March 26, 2003

This is in response to the DOE proposal "An evaluation of Alternative Qualifying Criteria for Energy Star Windows: February, 2003"

Three Climate Zones (U-Factor/SHGC)

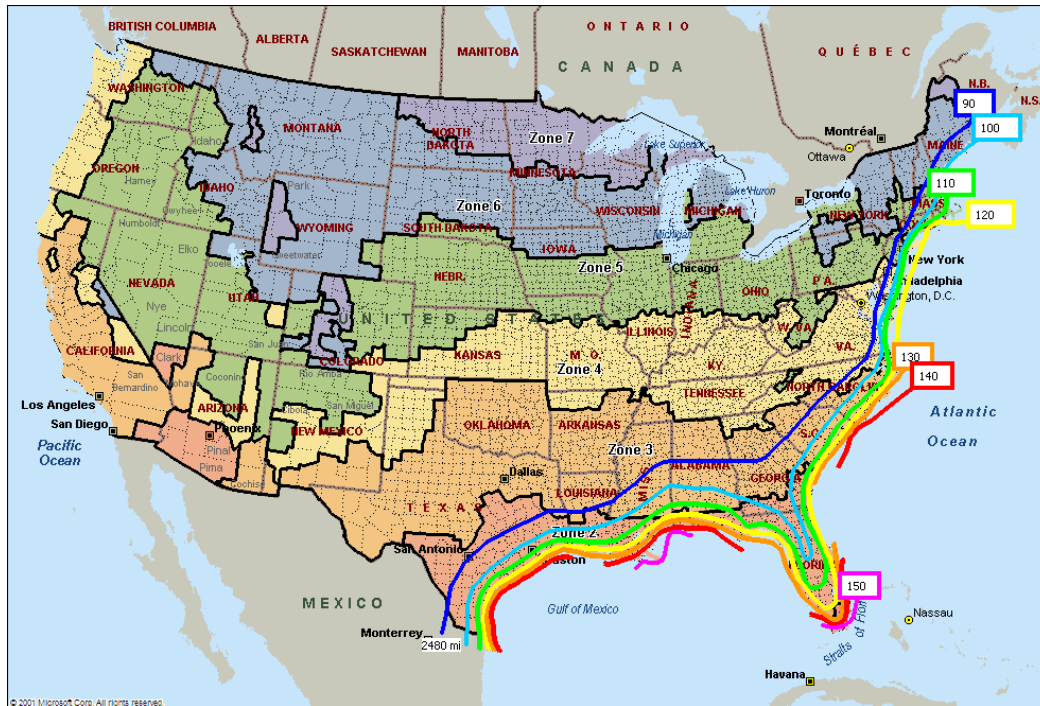
TRACO's recommendation is to use The March 2002 DOE scheme (3 climate zones) with suggested modification that the AEC has proposed,

Current	Proposed	AEC/TRACO
<u>Zone</u>	<u>Energy Star</u>	<u>Energy Star</u>	<u>Position</u>
South	0.75/0.40	0.65/0.40	0.65/0.35
Central	0.40/0.55	0.40/0.40	0.45/0.35
North	0.35/any	0.35/any	0.42/0.50
